| Project | IEEE 802.16 Broadband Wireless Access Working Group < http://ieee802.org/16 > |
| Title | Amendment to Idle Mode Service Primitives |
| Re: | Contribution on comments to IEEE 802.16g/D8 |
| Abstract | Re-definition of Idle mode service primitives in section 14.2.4.2 |

Figure 479—Subscriber mode transition diagram at NCMS ([on BS or MS side](#))

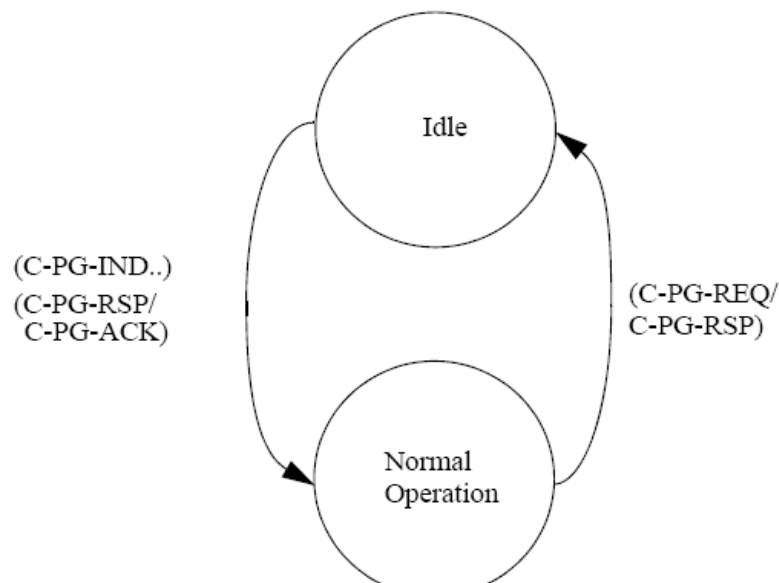
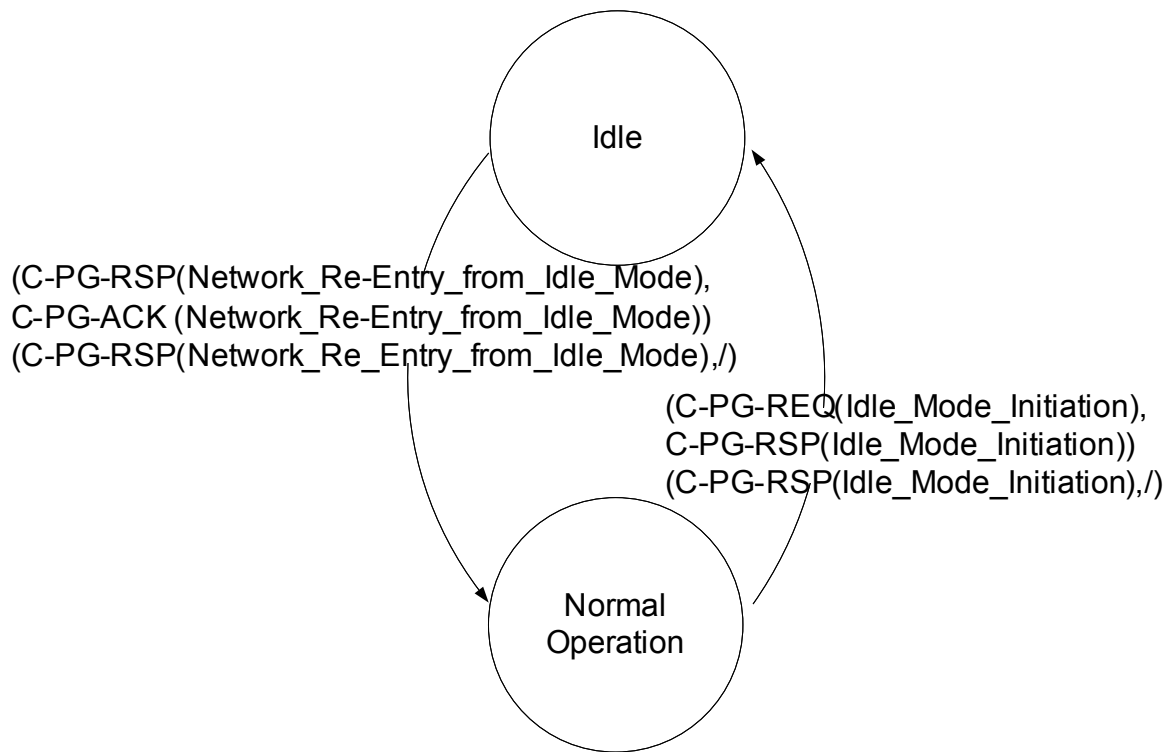
Subscriber mode management is described as informative in section 14.2.4 and it is managed at an MS, a BS and an NCMS. Figure 479 which shows subscriber mode transition diagram at an NCMS is not clear whether for an NCMS on a BS and an MS side or not.

Therefore, we clarify figure 479 and the related texts in order to be used both NCMS at an MS and a BS side.

Figure 479 shows Subscriber Mode transition diagram at the NCMS with service primitives related with the Subscriber Mode transition. Subscriber Mode transition from Normal Operation to Idle Mode is performed by exchanging C-PG-REQ and C-PG-RSP between ~~a BS~~ an 802.16 entity and the NCMS after successful DREG-REQ message from the MS with De-Registration_Request_Code=0x01 or DREG-CMD message from the BS with Action Code = 0x05, where C-PG-REQ and C-PG-RSP are defined in 14.2.4.2.1 and 14.2.4.2.2, respectively. Subscriber Mode transition from Idle Mode to Normal Operation is initiated after exchanging ~~C-PG-IND, C-PG-RSP,~~ and C-PG-ACK between an 802.16 entity ~~BS~~ and the NCMS, where ~~C-PG-IND, C-PG-RSP,~~ and C-PG-ACK are defined in ~~14.2.4.2.4,~~ 14.2.4.2.2, and 14.2.4.2.3, respectively.

The parenthesis in figure 478 and 479 consists of condition and action for state transition, (condition, action). For example, (C-PG-REQ, C-PG-ACK) means that if an NCMS receives C-PG-REQ, it sends C-PG-ACK. If there is no action, we use the '/'. For example, (C-PG-RSP, /) means that if the NCMS receives C-PG-RSP, it does not perform any action.

Figure 480 – Idle mode initiation (NCMS on the MS side)

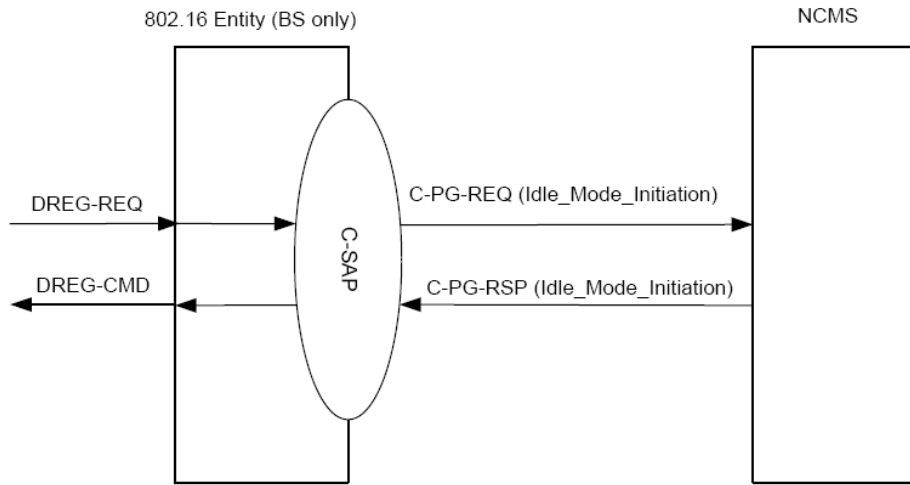
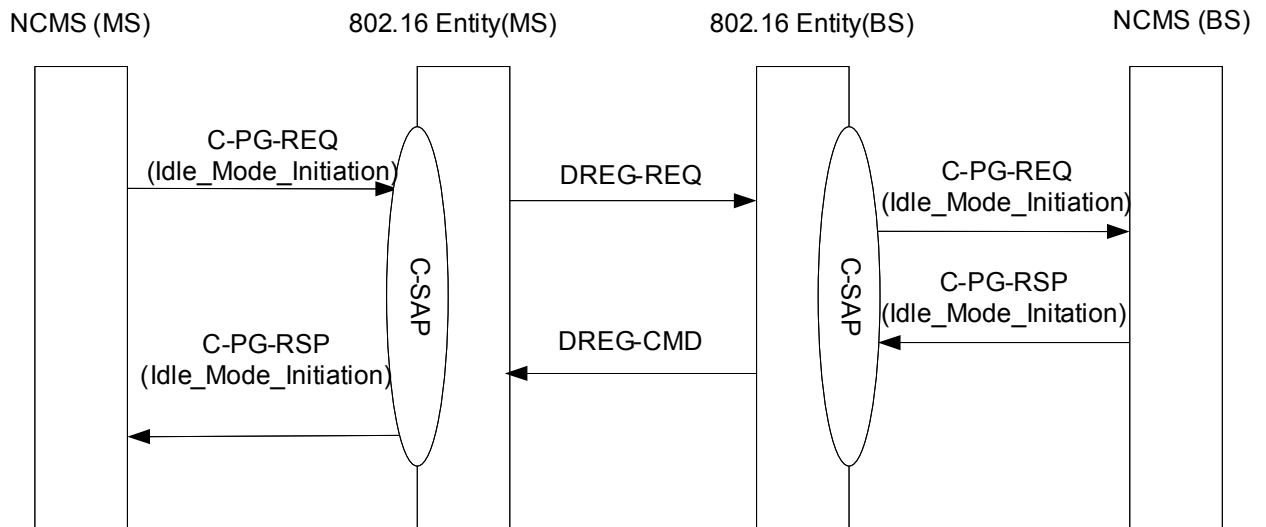
Therefore, we propose to change figure 480, 482, 483 to the figures which are included the service primitives between an 802.16 entity (MS) and an NCMS on the MS side and modify the related service primitives parameters in this contribution. And we also correct some editorial texts.

[Change the figure 480 and its title to as follows]

Figure 482- Paging Announcement

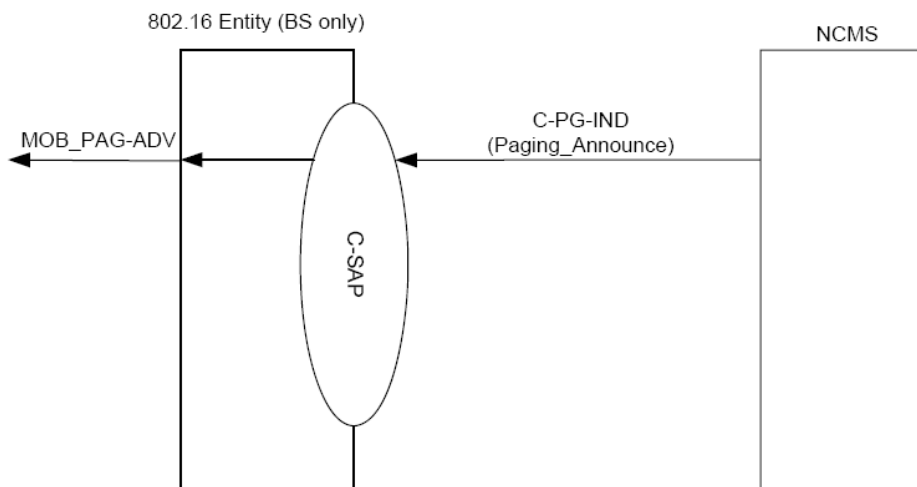
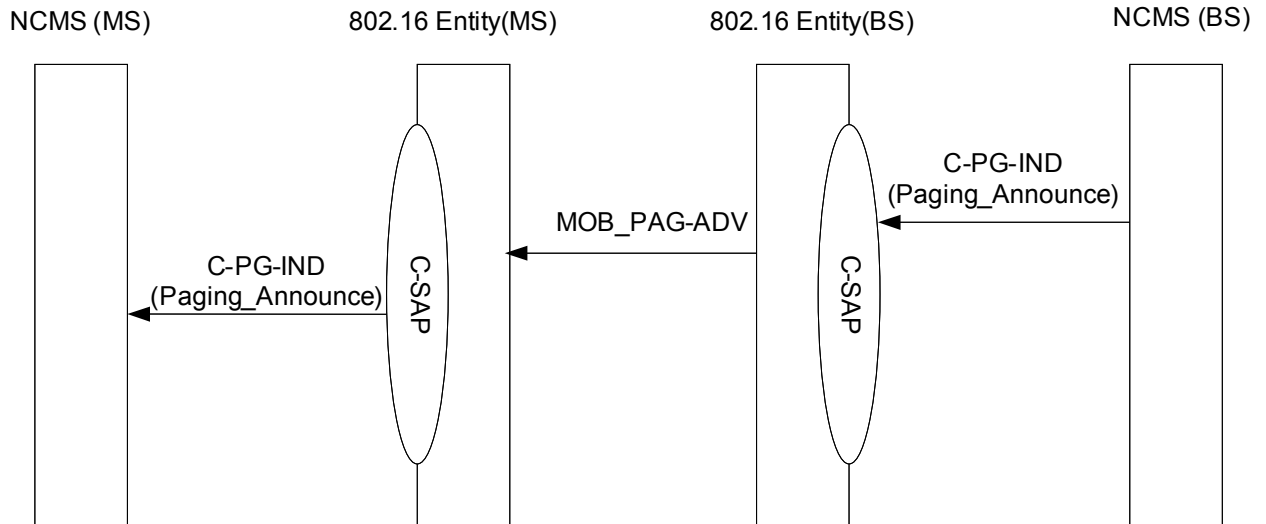
[Change the figure 482 to the following figure Section 14.2.4.2]

Figure 483- Network re-entry from Idle mode primitives

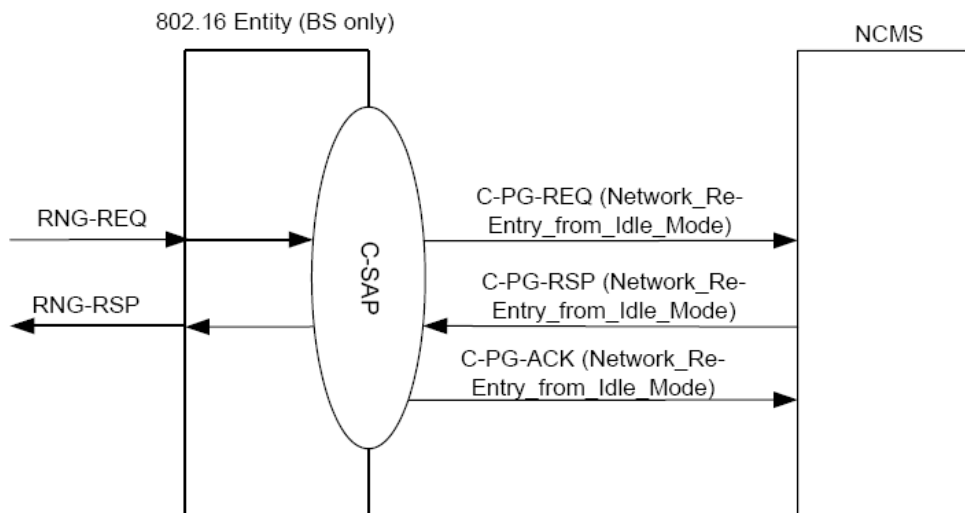
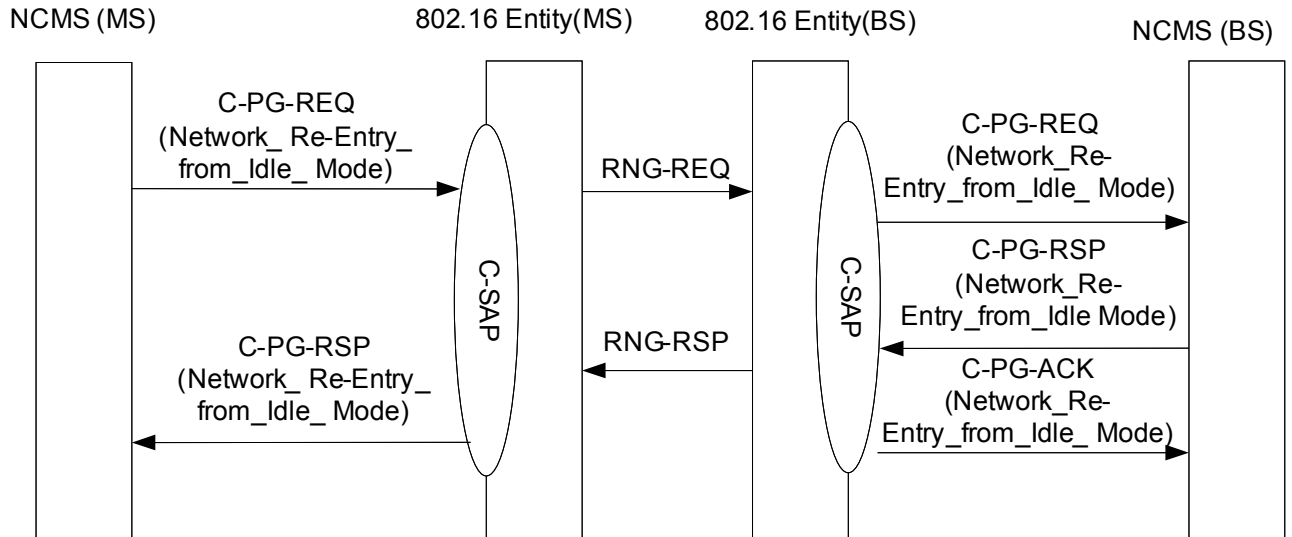
[Change the figure 483 to the following figure in 14.2.4.2]
